<b>Product Name:</b>	514 - Minitek Power	
	MTK PWR 3.0 8 Position SMT header and 12P BMI header	
<b>Product Manager:</b>	Jithin George	
<b>Subject:</b>	Notification of Change with Immediate Effectivity	
<b>Distribution:</b>	Affected customers	
<b>Type of Change:</b>	Packaging Change	
<b>Change Description:</b>	Box Quantity increased. Kapton tape length increased for improving the connector picking. Changes are described in attached PPT. These changes do not affect Form, Fit & Function of the product.	
<b>Reason for Change:</b>	Product Design Improvements to meet various Customer requirements	
<b>Affected Parts:</b>	List the affected part numbers or attach file. If attaching file, enter Filename(s).	
<b>Effective Date of Change:</b>	May,15 2022	
<b>Last Time Buy Date:</b>		
<b>Earliest Disty Return Date:</b>		
<b>Last Time Shipment Date</b>		
<b>Datasheet Attached?</b>	No	
<b>Qual/Test Data Attached?</b>	No

# ENGINEERING CHANGE NOTIFICATION

Product: 10137926 Minitek Power 3.0 8Pos Vertical SMT header

- Site CCB No./Global PCN No. - COK-025-22
- Implementation Date: 15<sup>th</sup> May 2022

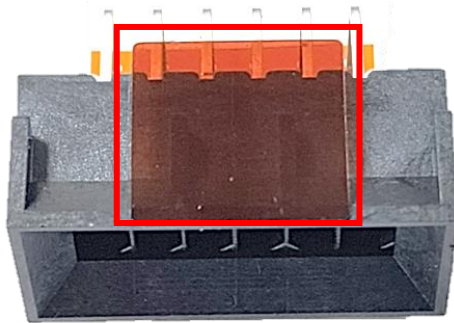
AFCI P/N	POS	Reel Size Dia	QTY /Reel	Box size (mm)	Reel /Box	Tape width (W)	Pitch (P)
10137926-08XXXLF	8	330	200	340*340*220	5	44	20

✓ Packaging : Standard packaging qty : 1000 pcs/Box

AFCI P/N	POS	Reel Size Dia	QTY /Reel	Box size (mm)	Reel /Box	Tape width (W)	Pitch (P)
10137926-08XXXLF	8	330	200	340*340*340	6	44	20

✓ Packaging : Standard packaging quantity changes to :1200 pcs/Box

Product: 10144754 Minitek Power 3.0 12Pos Right Angle BMI header

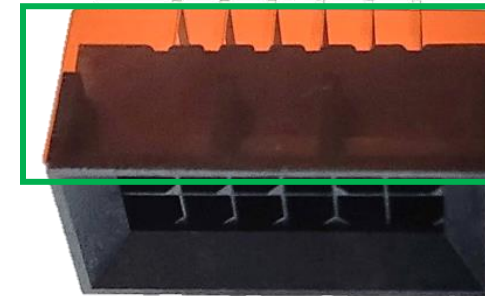
✓ Design : Kapton tape dimension of connector 10144754-1241KLF

✓ Design : Kapton tape dimension of connector 10144754-1241KLF changes from 12x12mm to 12x25mm
